Title:	T3 Rear Steer Air Venting			
Number:	WB_653	Release Date:	10/02/23	
Revision Number:	Not Applicable	Revision Date:	Not Applicable	
Chassis Type:	Any custom chassis with T3 suspension			
Component Description:	T3 rear axles Base #'s 2878300 and 2878301			
Warranty:	Parts and 3 hours' labor are covered under the Warranty. <i>*This is NOT A CAMPAIGN or RECALL. All claims subject to terms & conditions per customer Service Policy & Procedure Manual</i>			
Parts:	Mufflers (PN 51-4141, 56-4112-0002, 56-0493-001), Gear Box Vent Valve (2785640)			
Tools:	Not Applicable

Oil leaks caused by improper venting of the T3 rear axles.

WARRANTY BULLETIN #653

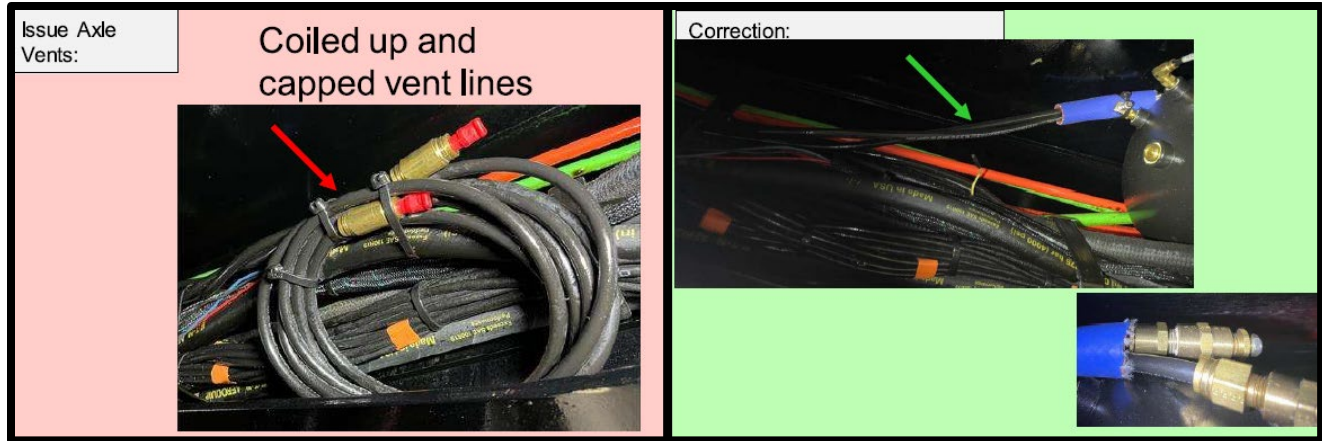
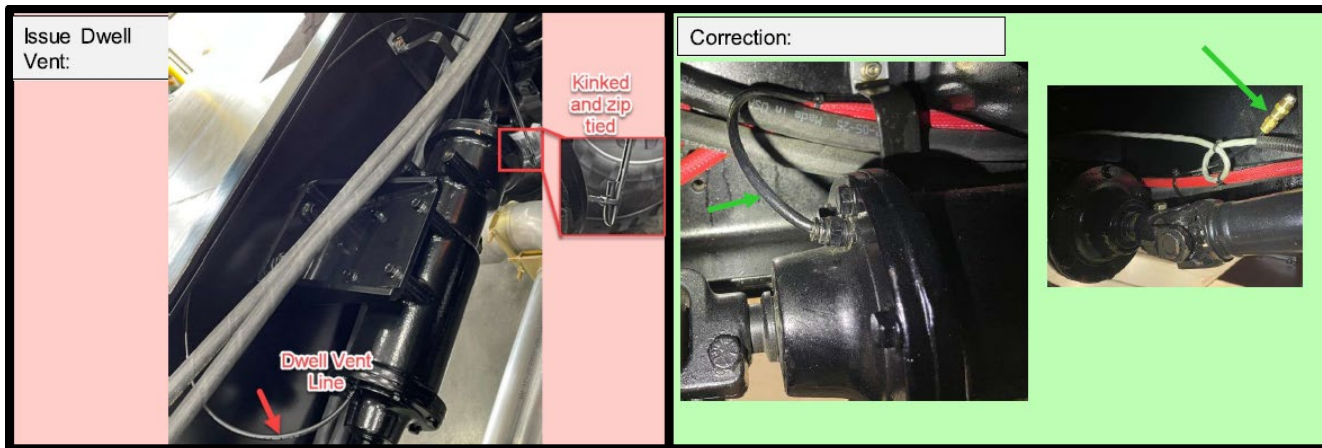
2. Inspect axle vent line routing and end fittings.
 - a. Tubing shall not be coiled up.
 - b. Mufflers must be free and clear of any objects and obstructions.

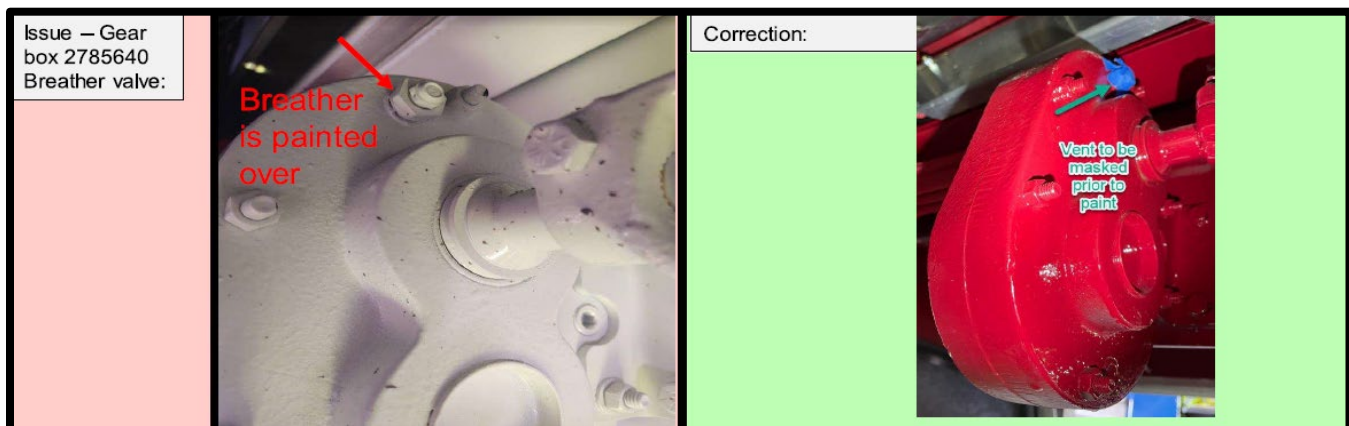
3. Inspect Rear Dwell routing and end fittings.
 - a. Tubing shall not be coiled up.
 - b. Mufflers must be free and clear of any objects and obstructions.
